Work Order ID 88697

Item Name: Crosstube Fwd

DRAWING NO. D206-667-143		REV. C SHEET 1 OF 4	
TITLE CROSSTUBE ASS'Y (206L HIGH FWD)		SCALE NTS	
<small>COPYRIGHT © 2006 BY DART AEROSPACE LTD THIS DOCUMENT IS PRIVATE AND CONFIDENTIAL AND IS SUPPLIED ON THE EXPRESS CONDITION THAT IT IS NOT TO BE USED FOR ANY PURPOSE OR COPIED OR COMMUNICATED TO ANY OTHER PERSON WITHOUT WRITTEN PERMISSION FROM DART AEROSPACE LTD.</small>

DRAWING NO. D206-667-143	TITLE CROSSTUBE ASS'Y (206L HIGH FWD)	REV. C	DART AEROSPACE LTD ENGINEERING ORDER		D.E.O. NO. D206-667-143-C-1	SHEET NO. SHEET 1 OF 1	SCALE NTS
DRAWN 92	CHECKED ASS	MFG. APPR. 1/8	APPROVED MD		DE APPR. 1/8		
DATE 11.07.15	DATE 11.07.20	DATE 11.07.21	DATE 11/07/21		DATE 11.07.21

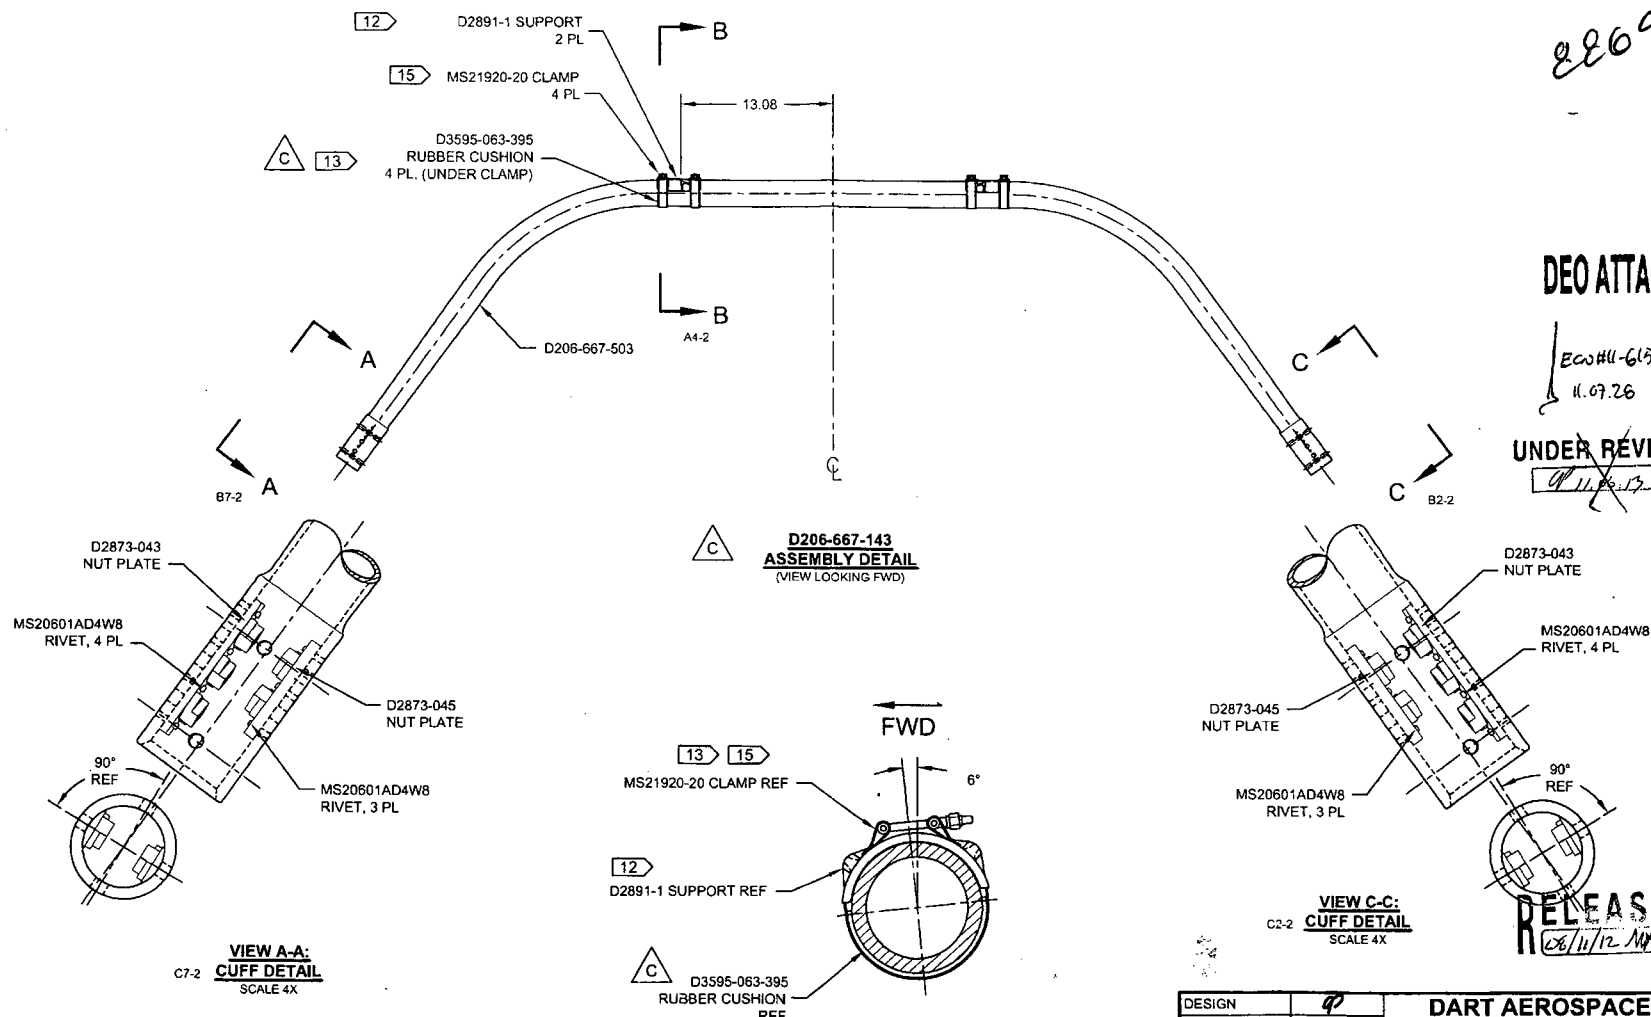
REPLACE MAGNOBOND WITH PROSEAL.

NOTE 12 &amp; 15, SHEET 1 IS AMENDED AS FOLLOWS:

- 12) TO INSTALL D2891-1 SUPPORT: ABRASE MATING SURFACE OF SUPPORT AND CROSSTUBE WITH 180-GRIT SANDPAPER AND REMOVE RESIDUE WITH MEK (OR EQUIVALENT). APPLY A 0.04" TO 0.07" THICK LAYER OF PROSEAL 890 CLASS B-2 (OR AMS-S-8802 CLASS B-2) SEALANT TO MATING SURFACE OF SUPPORT.
- 15) TORQUE CLAMPS 80 TO 100 IN.-LB. ENSURE AT LEAST 1.5 THREADS SHOWING IN SAFETY AND THAT NUT HAS NOT BOTTOMED-OUT AFTER TORQUING. **PRIOR TO PACKAGING, RE-CHECK TORQUE ON CLAMPS AFTER PROSEAL 890 SEALANT HAS CURED FOR 72 HOURS.**

**FIGURE 1 - GROUNDING STRAP INSTALLATION**  
(VIEW LOOKING FWD)

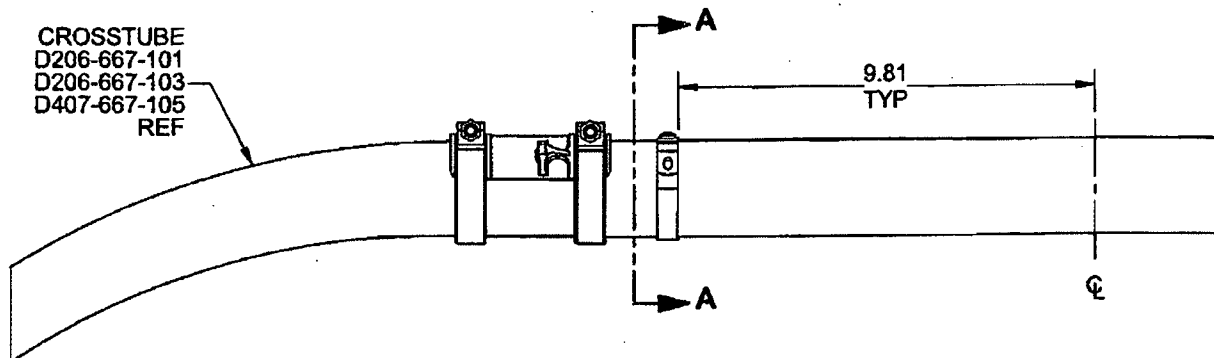
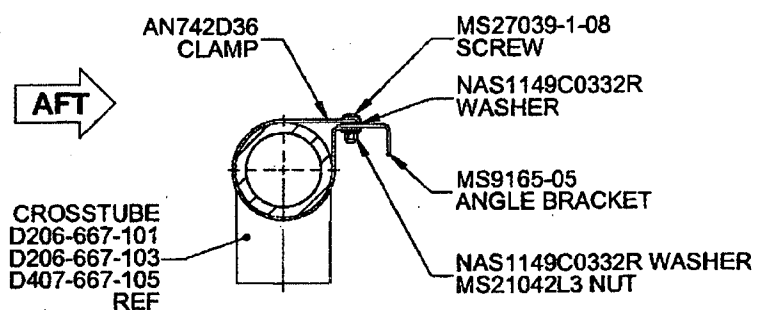
The purpose of this service instruction is to add the optional D206-667-017 Kit and provide guidelines to install extra clamps on D206-667-101/-103 or D407-667-105 forward crosstubes to allow fastening of OEM grounding straps.

- 1) If installed, follow Section 32.1 of ICA-D206-667 for removal of the forward crosstube from the helicopter.
- 2) Locate AN742D36 Clamp as shown in Figure 1 of this service instruction and mark location of clamp on the crosstube.

- 3) Remove crosstube finish (paint and primer) in area where AN742D36 Clamp will be installed and touch up affected area with chemical film material (Alodine 1200 or 1201) per MIL-C-5541.

- 4) Install AN742D36 Clamp complete with MS9165-05 per Section A-A of Figure 1 of this service instruction.
- 5) Touch up paint as required per Item 5.3.3 of ICA-D206-667.
